H. B. ROBINSON UNIT NO. 2  
LICENSE DPR-23

ADDITIONAL INFORMATION - EFFECT OF AXIAL FLUX SHAPE ON LOCA

H. B. ROBINSON UNIT NO. 2  
LICENSE DPR-23  
ADDITIONAL INFORMATION CONCERNING LOSS-OF-COOLANT ANALYSES  
JANUARY 3, 1974

FIGURE 2-1  
FLOODING RATE VS. TIME  
FOR CPL DECL-G

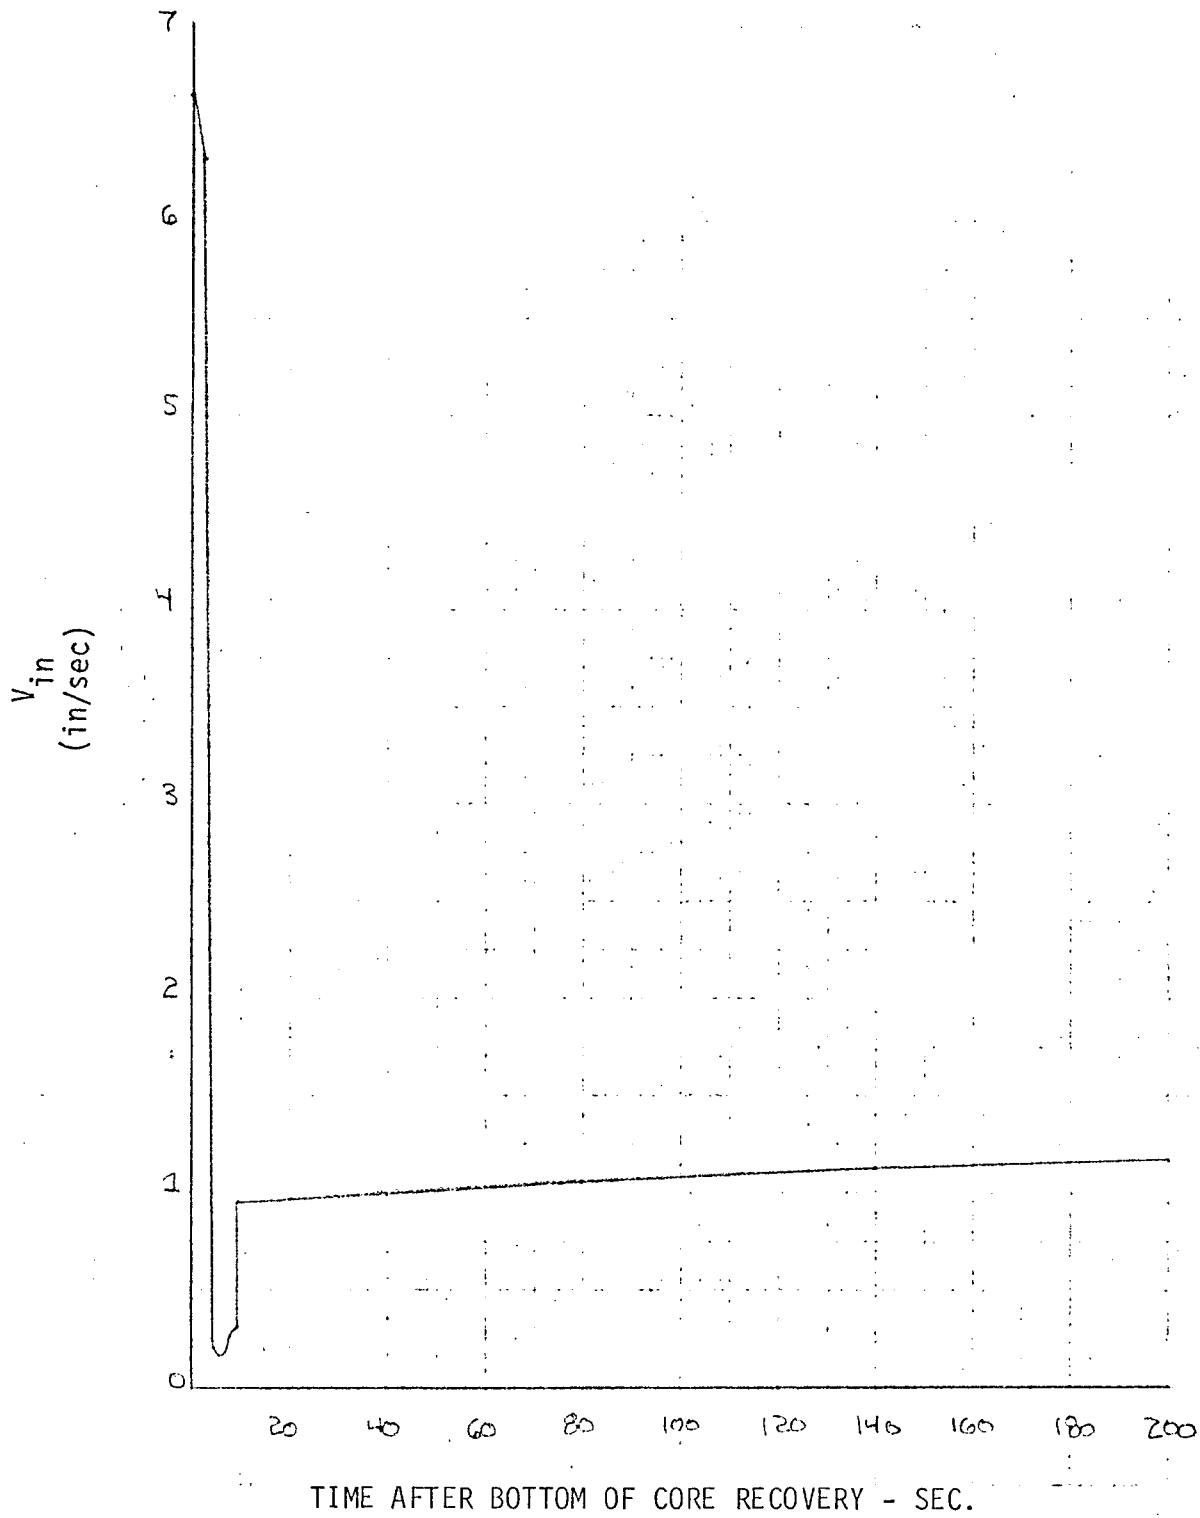
Describe how the core reflooding rate (Figure 1) is modified for use as input to the computation of FLECHT heat transfer coefficients; include the actual values used in each case.

The core flooding rate shown in Figure 1 of the previous submittal is not actually modified for use as input to the computation of FLECHT heat transfer coefficients for all of the power shapes analyzed. This flooding rate is calculated using the carryover fraction specified in the Interim Acceptance Criteria for W reactors. This carryover fraction is conservatively high and tends to yield lower core flooding rates.

The flooding rate presented in Figure 1 is used directly in the calculation of the heat transfer coefficient. However, in order to apply the FLECHT correlation to a varying flooding rate, the history of the reflood transient must be considered. This is accomplished by using a pseudo time in the FLECHT correlation which is calculated as the integral of the reflood water that entered the core up to some time (t) divided by the actual flooding rate at time (t). That pseudo time is used as the time argument in the FLECHT correlation.

Figure 4-1. Schematic Diagram of Quench Front Curves of a FLECHT Test and a Skewed Power Case

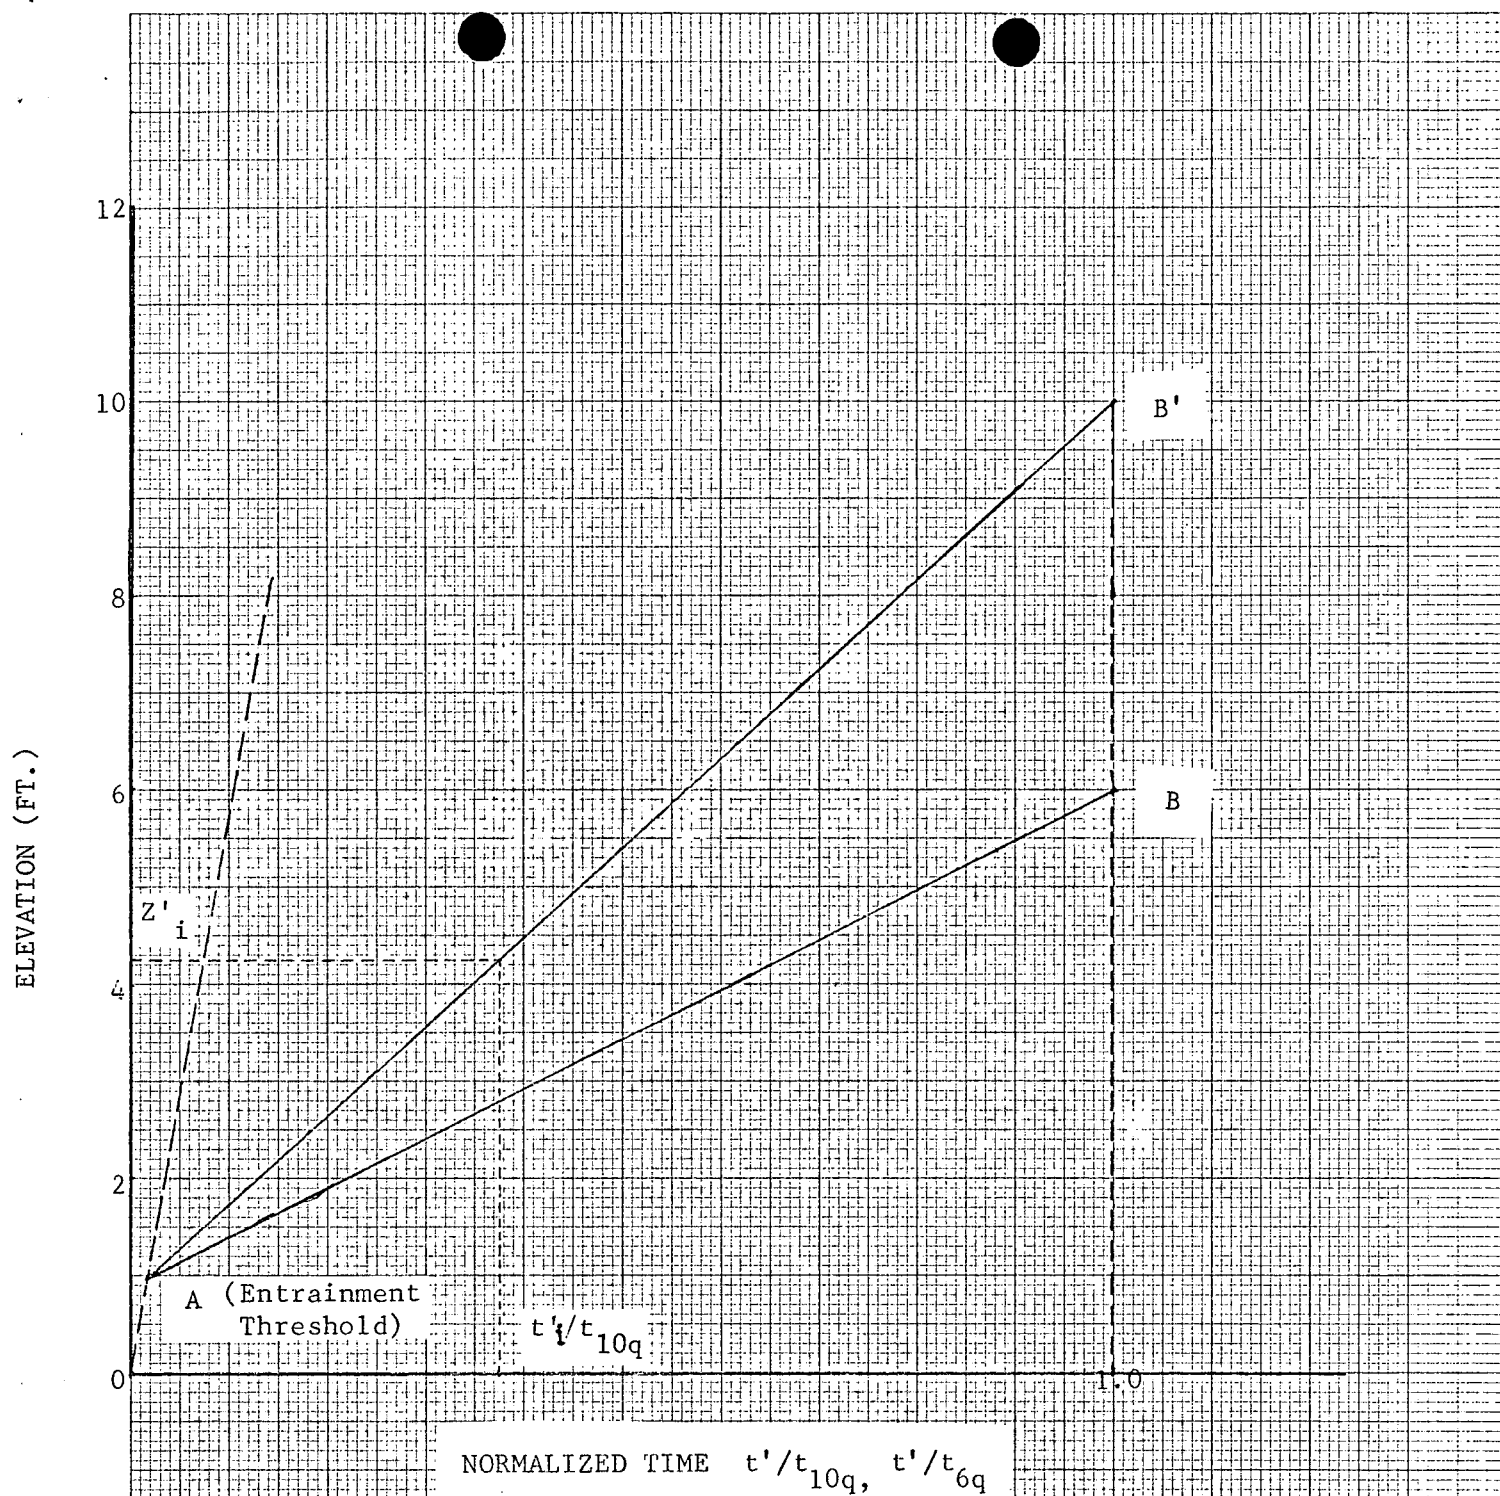
The FLECHT correlation is keyed to a symmetric flux shape with a flux peak at 6 ft., the initial cladding temperature at 6 ft., the heat generation rate at the 6 ft. level, the time to quench the 6 ft. elevation, and the integral of heat release up to the point in question. All of these factors vary when the axial shape is non-symmetric. Describe, in detail, the mathematical treatment that is applied to FLECHT data to generate heat transfer coefficients at any elevation.

It appears in the response to Question 5 that the heat transfer coefficients at the upper elevations were taken directly from symmetric shape data. In order to clarify this matter, provide the input data, and suitable justification, for each of the three curves on Figure 2.

The method consists of first constructing a quench front curve for the skewed power shape and a corresponding cosine FLECHT power shape in which the total integrated power up to the six-foot elevation is the same as the integrated power up to the peak location for the skewed shape. This quench curve is a plot of quench front elevation versus time. The skewed bundle peak location quench time can then be calculated using the FLECHT quench correlation with the appropriate power peak calculated to preserve the total skewed profile power up to the peak. Comparisons made using FLECHT data for cosine power shapes of varying peak power levels verify that, for elevations below the peak power elevation, quench time is a function of integrated power beneath the quench front and not the quench front elevation (within the range of FLECHT conditions). It follows that the calculated quench time for the equivalent FLECHT cosine power shape is the same quench time for the skewed power shape. This fixes one point on the quench curve for the skewed power shape. The second point of the quench curve is the point where "cold filling"

In order to calculate the heat transfer at the peak elevation for the skewed power shape, it is necessary to match up the skewed power quench curve and compare locations and times to the 6-foot FLECHT quench curve. Since the two normalized quench times are equal, the 6-foot FLECHT power peak is adjusted to preserve the same total power below 6' and below the peak location of the skewed power profile. That is
